**DEPARTMENT OF PLANNING AND
COMMUNITY DEVELOPMENT**

CASE NO.: 98-CUP-012 (Lighting Plan)

REQUEST: Request for approval of an exterior lighting plan for an office complex.

AGOURA HILLS CORPORATE POINT
 30200 & 30300 AGOURA ROAD
 AGOURA HILLS, CA

ARCHITECT: HENEY DONG & ASSOCIATES

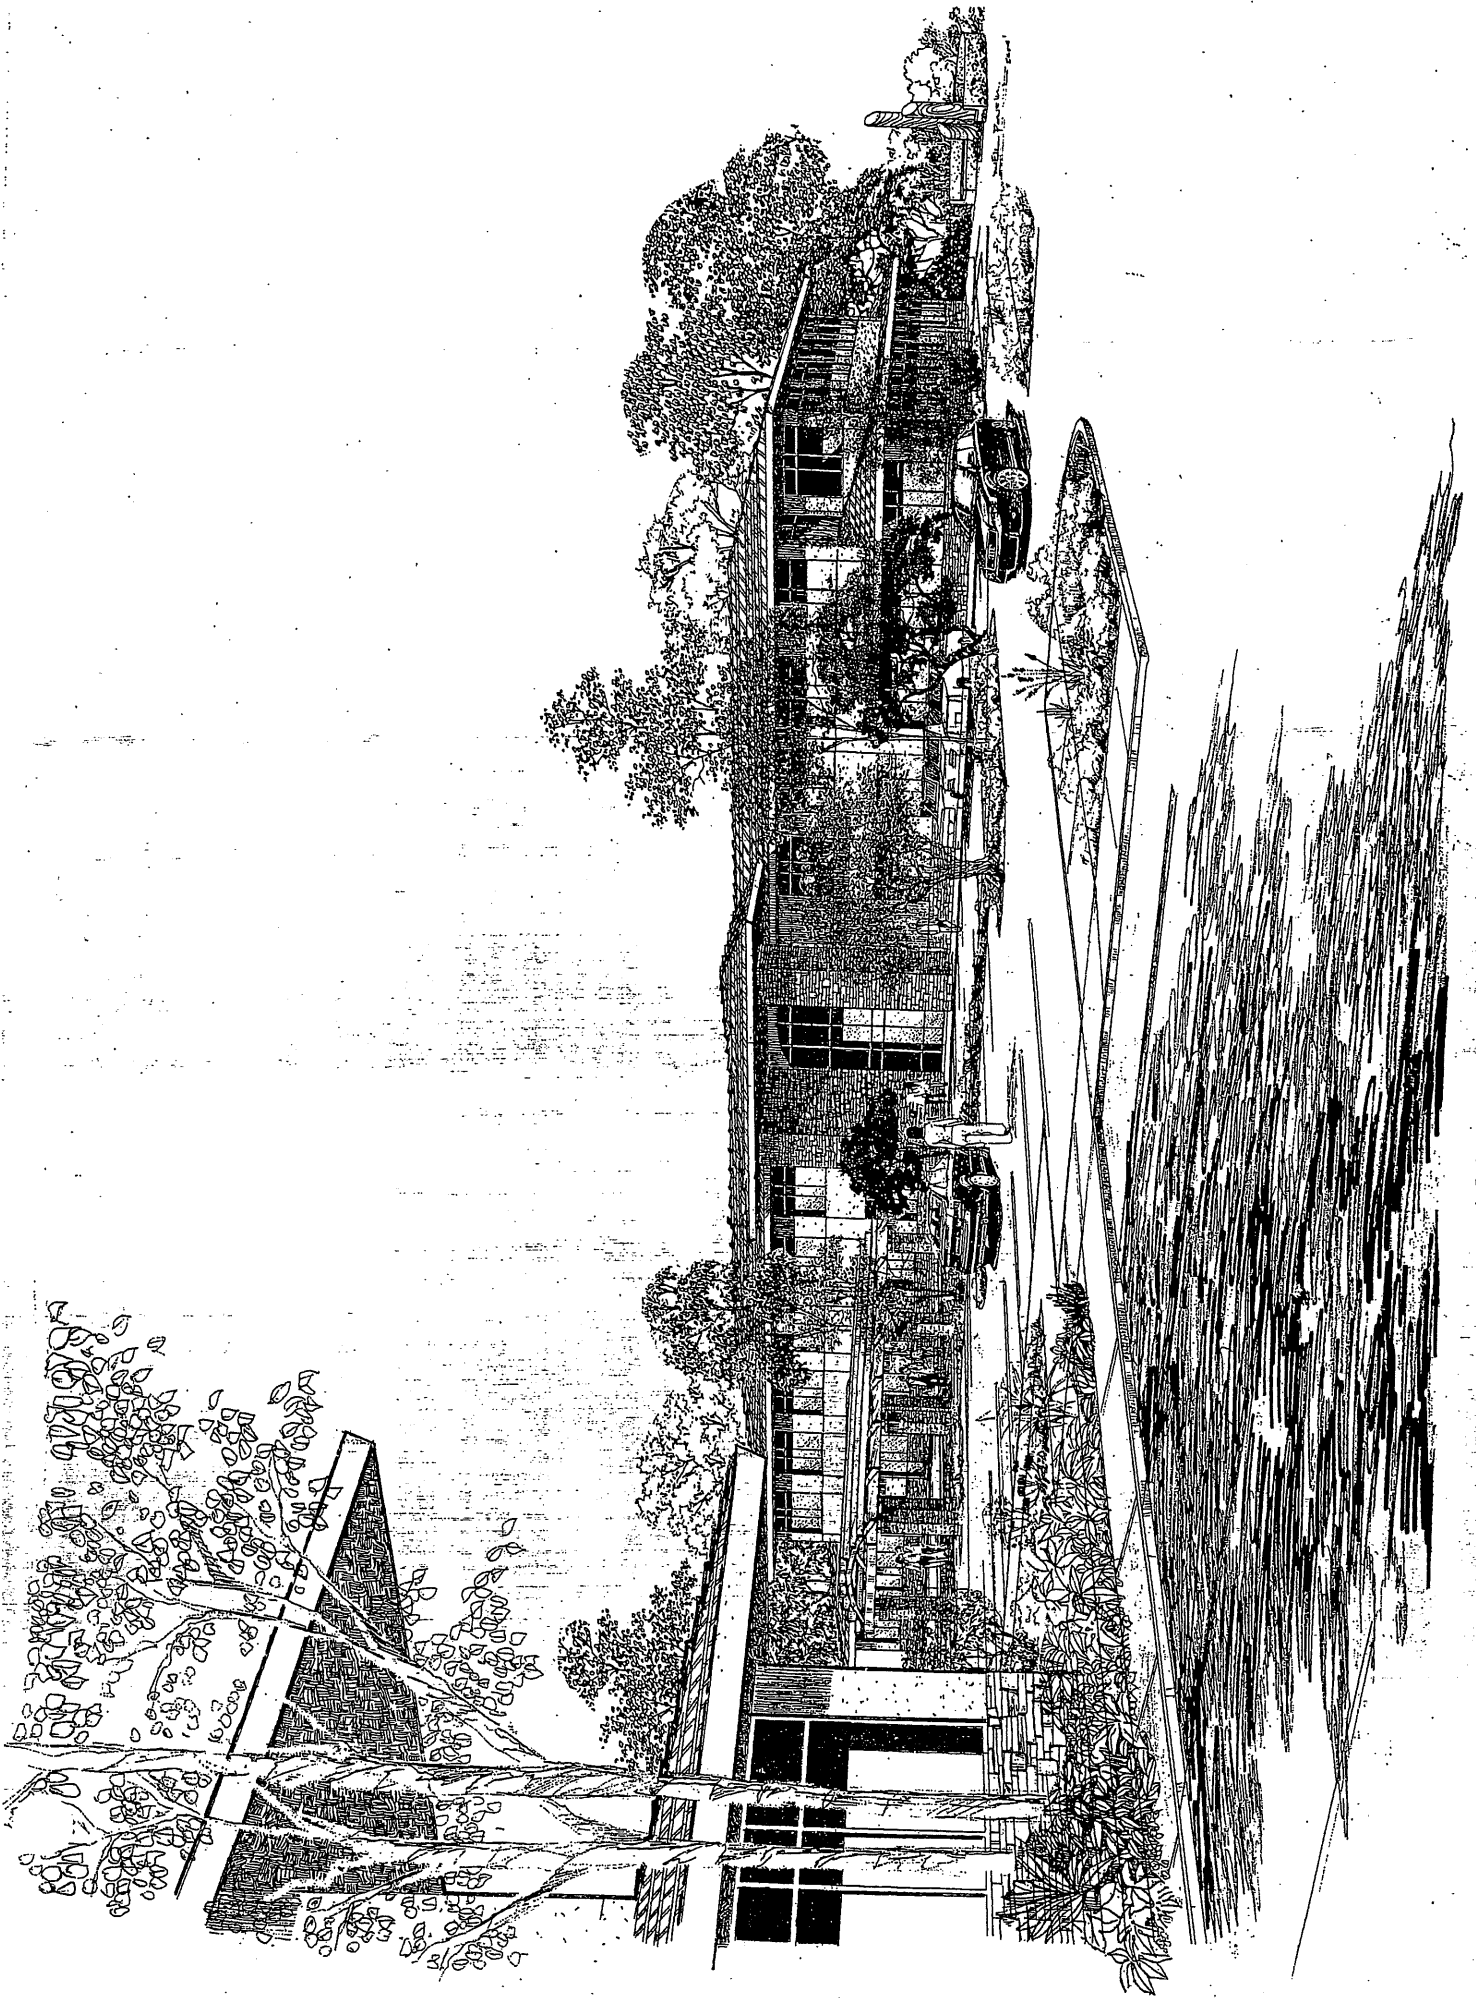
The project is currently in building and grading plan check with the Building and Safety Department. The applicant has submitted a lighting plan for the Planning Commission's review that includes proposed exterior light fixtures for the project's parking lots and drive-aisles. Each proposed fixture is circular in shape with a cutoff lens that is flush with the bottom of the fixture. All proposed fixtures and support poles include a bronze finish that is intended to be compatible with the building. Staff recommends that the cement mounting base of each fixture pole be stuccoed and painted to either match the color of the light fixtures or the building. The maximum height allowed by the City for each fixture, including the mounting base, is 16 feet.

The applicant is also proposing metal halide illumination for the fixtures. While the metal halide illumination is energy efficient, the Planning Commission has the discretion to require an even more efficient source of light emitting diodes (LED), if it is deemed more appropriate for the project. No wall mounted fixtures are proposed for this project since they are specifically prohibited in the project's conditions of approval.

Staff finds the proposed lighting plan to be in compliance with the City's Lighting Standards and Guidelines, as well as with the design of the office project. The Lighting Standards and Guidelines call for exterior lighting to be "sensitive to the character of the surrounding neighborhood to reduce negative visual impacts and glare onto residential neighborhoods, the freeway corridor, and public areas. Proximity to hillside areas, park land, rural or other similar areas will also require increased sensitivity to use exterior lighting. Areas of sensitivity may require more subtle lighting. Illumination levels shall not exceed one (1) footcandle at the property lines, measured at ground level. However, pedestrian areas and areas near the building that are accessible to the public and not clearly visible from the street or parking lot should be appropriately illuminated for public safety." The Lighting Standards and Guidelines also call for parking lot lighting to be "designed or selected to compliment the architecture of the building, and provide the minimum safe lighting levels. The required parking lot lighting plan shall be prepared with an understanding of the business hours of operation, as well as the intention to minimize lighting levels when the building is not occupied."

Since the property is within an environmentally sensitive hillside area, with adjacent designated open space land, it is important that the exterior lighting not be imposing. Toward that end, the applicant is proposing light fixtures strictly within the parking lots and drive-aisles. The illumination levels will not exceed one footcandle at the property lines. The project will be prominently visible as the building pads will be higher than any commercial building in the city. In order to retain and ensure the semi-rural ambience of this area of the City and to reduce negative visual impacts within the freeway corridor, it is recommended that the actual illumination levels of all lighting fixtures be subject to field review and approval by the Director of Planning and Community Development upon installation. It is further recommended that exterior illumination levels be reduced by at least 50% at times when the office complex is closed.

8. The parking lot light poles and fixtures shall not exceed 16 feet in height, including the mounting base. The mounting base shall be stuccoed and painted to either match the light fixtures or the buildings.
9. Landscape/garden lights, if proposed, shall be subject to review and approval by the Director of Planning and Community Development upon approval of the project's final landscape plan.
10. Roof-mounted and/or roof parapet-mounted lighting is prohibited.

11. Exterior illumination levels shall be reduced by at least 50% at times when the office complex is closed.
12. The actual illumination levels of all exterior lighting fixtures shall be subject to field review and approval by the Director of Planning and Community Development, and the lighting may be subject to reduced illumination levels if determined to be necessary for compliance with the City Lighting Standards and Guidelines.
